From: Richard Duncan [REDACTED]
Sent: 19 July 2021 16:28
To: Robin Smithyman
Subject: Re. Proposed Lea Castle Farm Quarry and Restoration - Public Access Routes
Attachments: KD.LCF.033C PROW Proposals.pdf; KD.LCF.034C PROW - Post Restoration.pdf

From: Robin Smithyman [REDACTED]
Date: Friday, 30 April 2021 at 09:48
To: "Hayward, Rowena" <Rhayward@worcestershire.gov.uk>
Cc: "Aldridge, Steven" <SAldridge@worcestershire.gov.uk>
Subject: Re: Proposed Lea Castle Farm Quarry and Restoration - Public Access Routes

Subject: Proposed Lea Castle Quarry

REF NO:
KD.LCF.033C

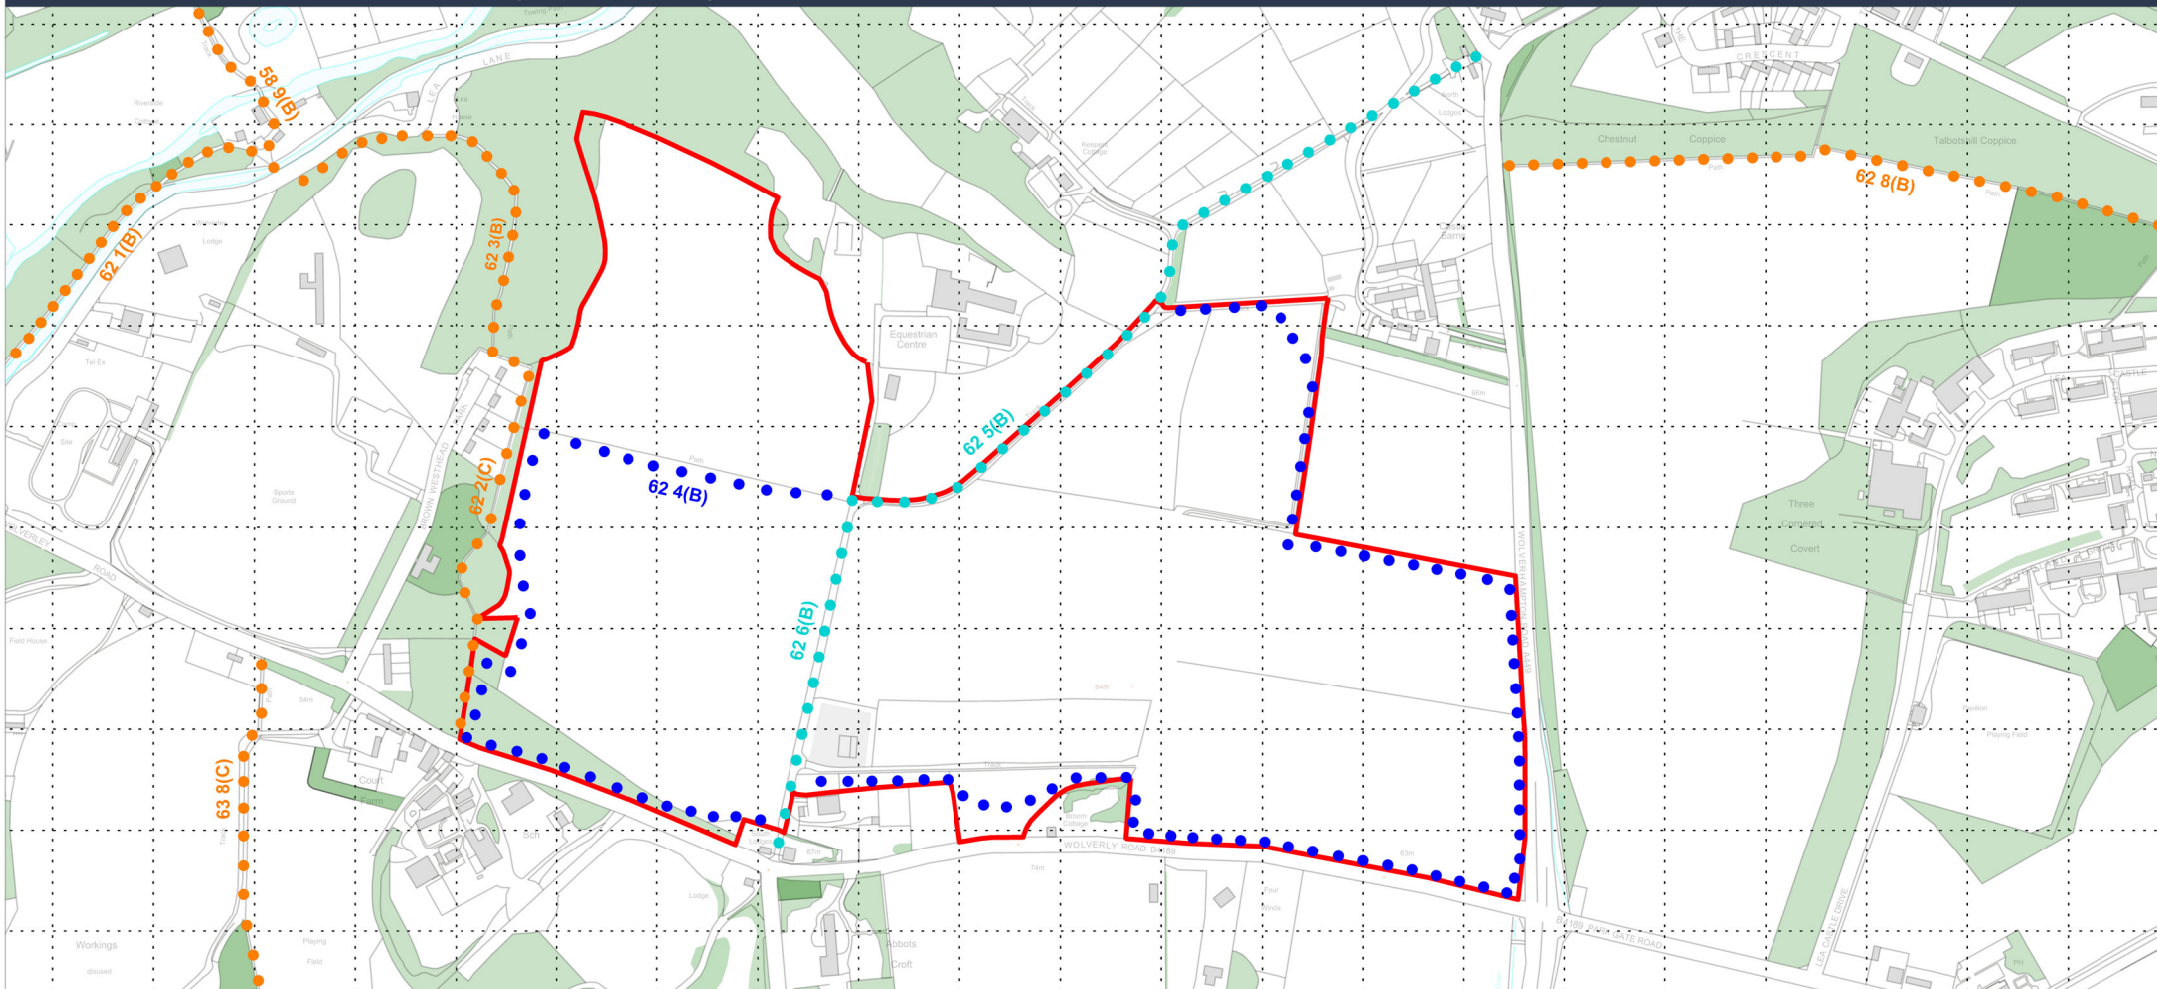
As regards the upgrades and changes to the footpaths and bridleways on the site I have the following queries:

The proposed upgrade of footpaths WC-622 and WC-623 to a bridleway.

- The route has steps at both ends which would be unsuitable for horses at the Lea Lane ends this is a significant rise in level.
- I have concerns about horses accessing onto the wolverley road at the southern end of footpath WC-622 as the road is very busy and fast moving and has only a narrow footway.

- The gap in the brick wall at this point is not currently wide enough for horses.
- The northern end of path does not currently follow the definitive line but exits through the brick wall opposite Lea House and we believe this to be an informal rerouting of long standing. The exit at this point is not wide enough for horses.

- Any upgrade of these routes will request full agreement from the landowner and I am not clear if this land is owned by the quarry site.
- In order for the current route to be upgraded to a bridleway the width will need to be 3m at a minimum and possibly wider if the area is enclosed. This width is not currently possible along much of the route.

- It may be more suitable to look at alternative routes which could be dedicated rather than a try to upgrade the existing route. This would need to have a definitive benefit to the network for us to be keen to accept the dedication.

The proposed upgrade of footpath WC-624 to a bridleway.

If the bridleways above are not to be upgraded it is not clear that there would be a benefit to the network in upgrading this when it will be a dead end route. If suitable links are provided and as long as the landowner is in agreement then I see no issue with this dedication as bridleway.

Additional Bridleways provided.

We would be willing to accept the dedication of some additional bridleways within the site however some of the routes appear to more in line with public open space rather than linking routes. I understand that a footpath link is suggested from the Wolverhampton Road/ Wolverley Road to access the site and reconstructed land on its eastern edge. If this link was provided then the outermost circular route is a clear improvement to the network. However the additional north south link within the site would appear to be an open space feature rather than a clear network improvement and would be more appropriately dealt with as a route provided within the site by those who will continue to maintain it rather than dedicated as a path on the definitive map. We would also suggest that the link from the road would not be suitable for horses due to the amount of traffic using the road, narrow footpath and the lack of bridleway on-links from this point.

It is noted that it may be more suitable to look at alternative routes within the planning application boundary to provide achievable benefits to the network. As such we attach a copy of Drawing No KD.LCF.033A and 034A which propose a new section of bridleway adjacent (to the east) of Public Footpath WC 622. This could be a dedicated route or permissive, managed and maintained by the landowner and enforceable by an appropriate planning condition. As with the current proposal this land is under the control of the applicant. It is confirmed that the required 3m width and associated bridleway specifications will be established for this and all new section of bridleways and that the current section of Public Footpath WC -622 will remain in place and in use.

Given the above we would still wish to upgrade this section of PROW to a bridleway. Again, it could be dedicated or permissive, managed and maintained by the landowner.

The scheme has been designed in a holistic manner, combining both benefits to the PROW network and general amenity. As such, I understand your comment in respect of what is potentially a dedicated route. As such, if one of the routes was dedicated, the landowner confirms that the other could be a permissive route secured and maintained under an appropriate planning condition.

REF NO:
KD.LCF.034C

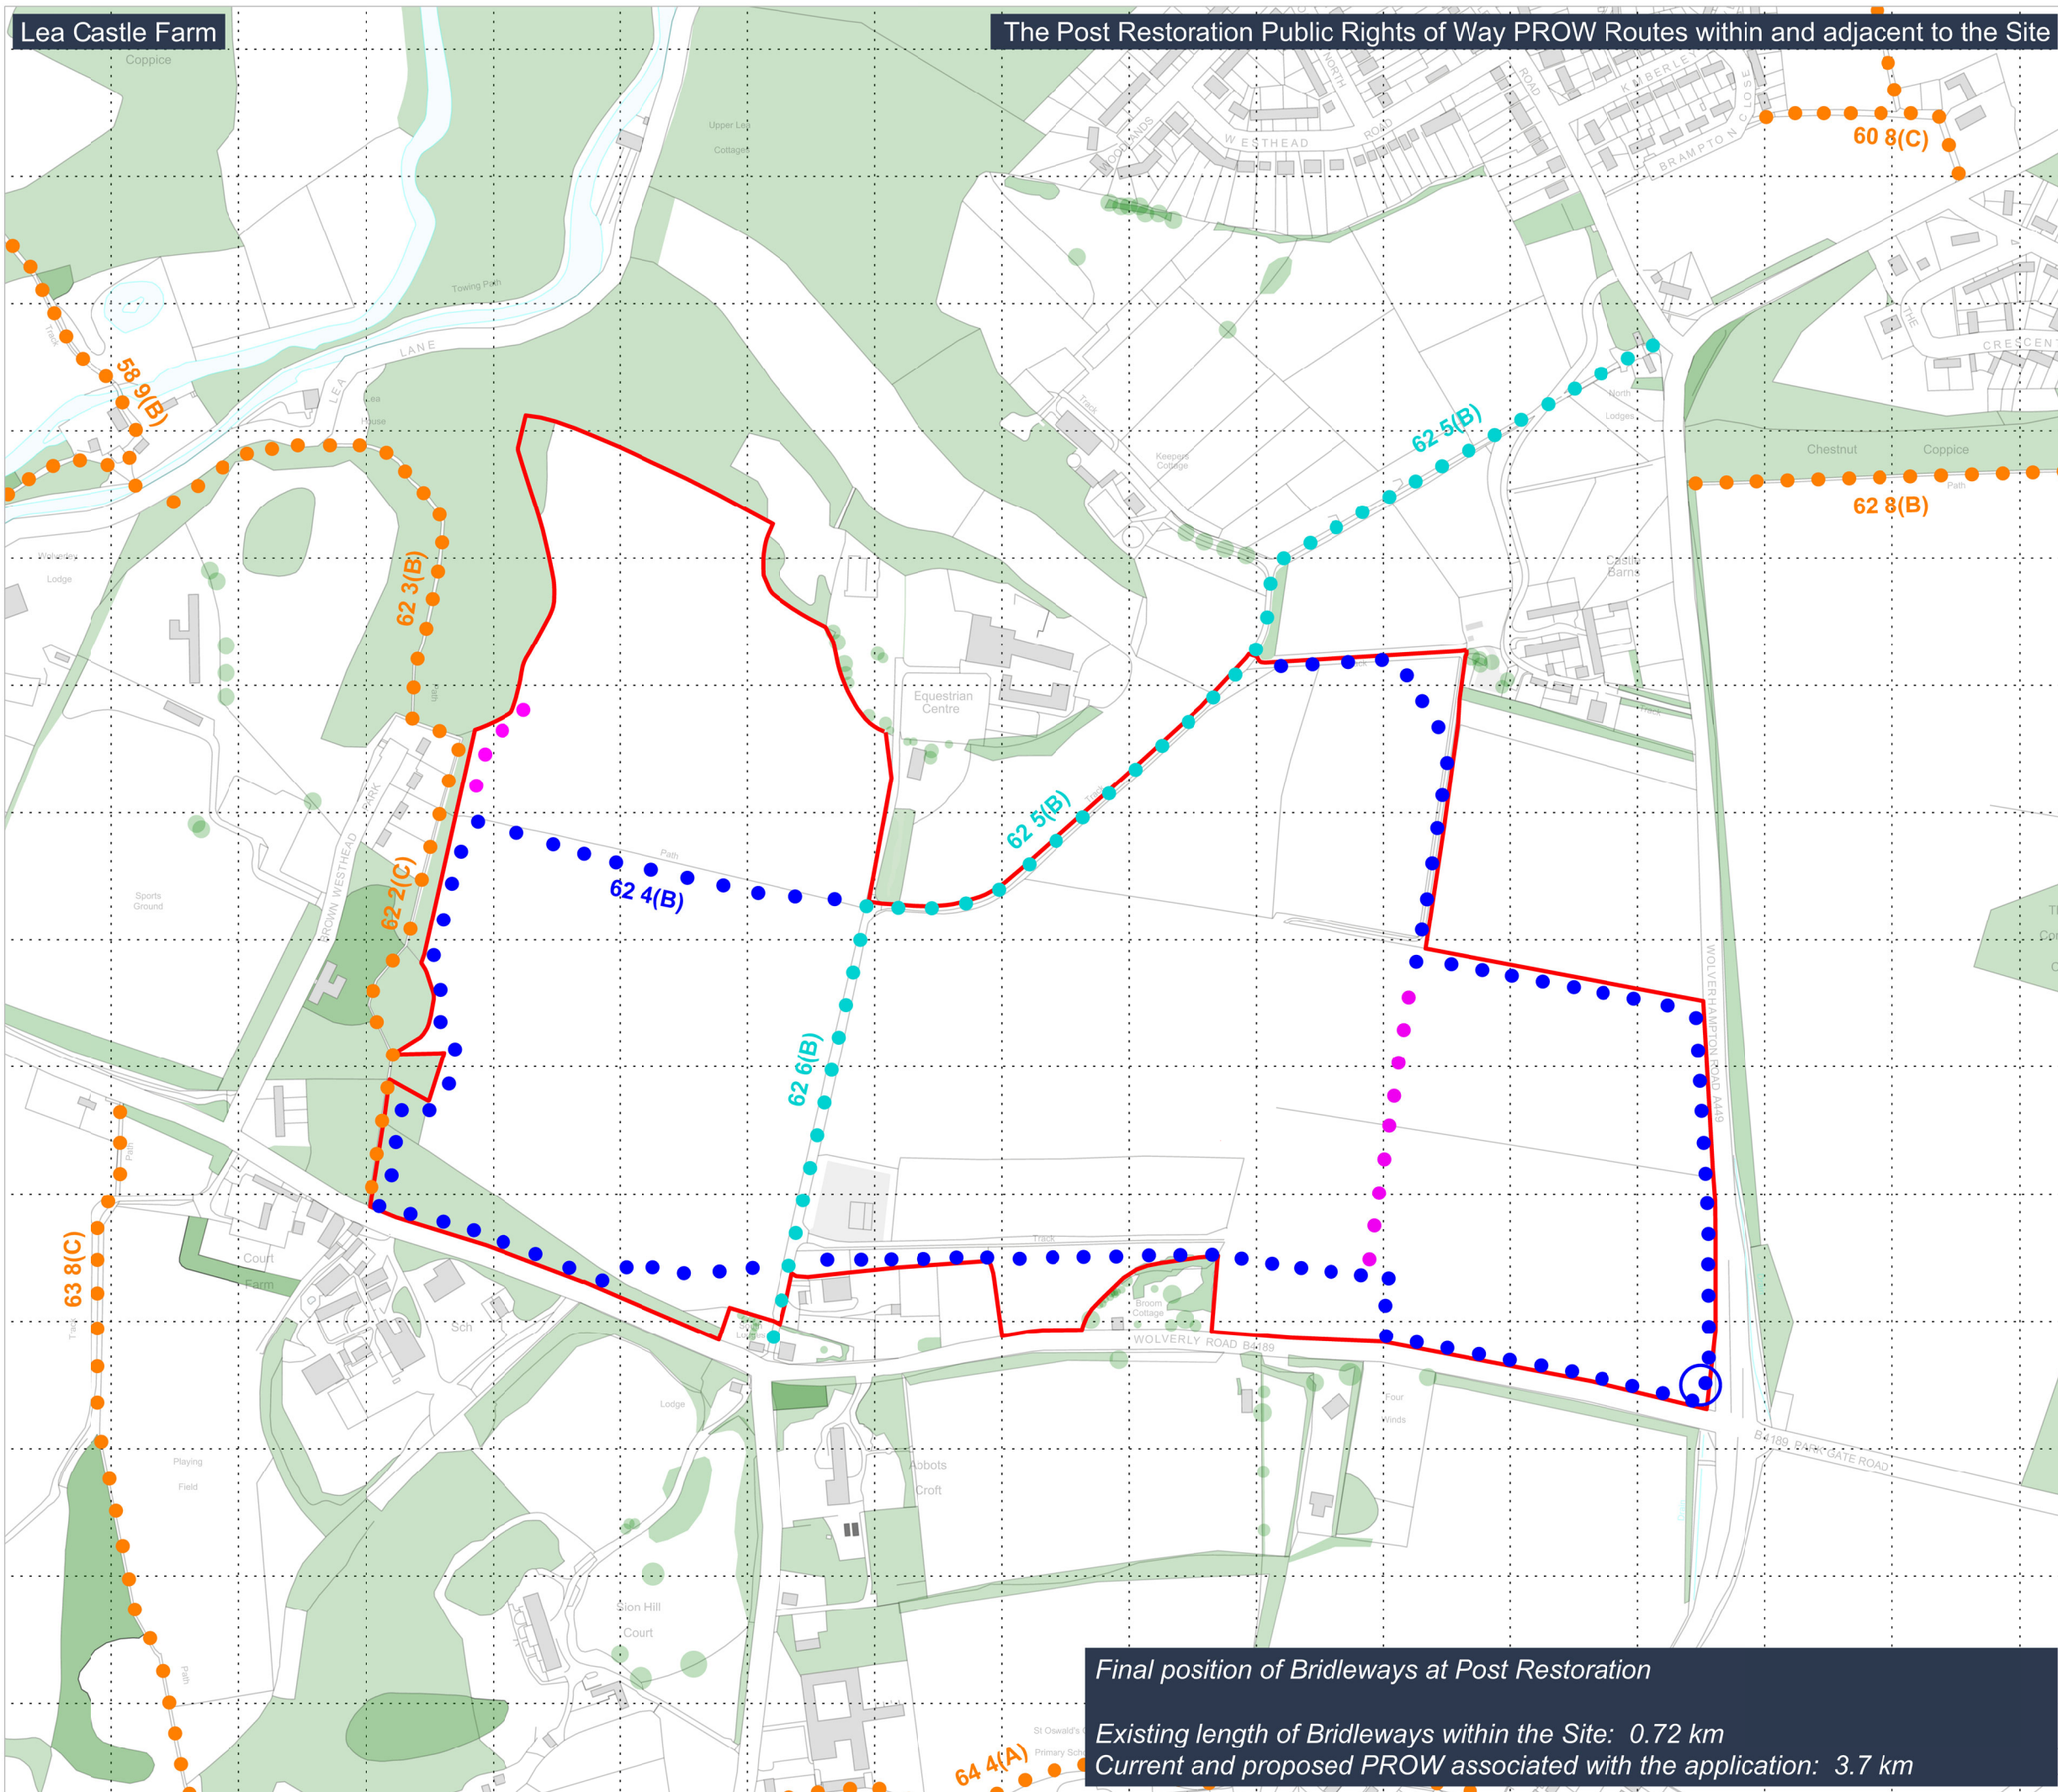
The new spur to the pocket park

This would be of benefit to the pocket park users only and would have no significant benefit to the network and would be more appropriate to be maintained as part of the pocket park rather than dedicated as a bridleway.

Yes, it is confirmed that this would be a permissive route managed and maintained by the landowner and enforceable by an appropriate planning condition.
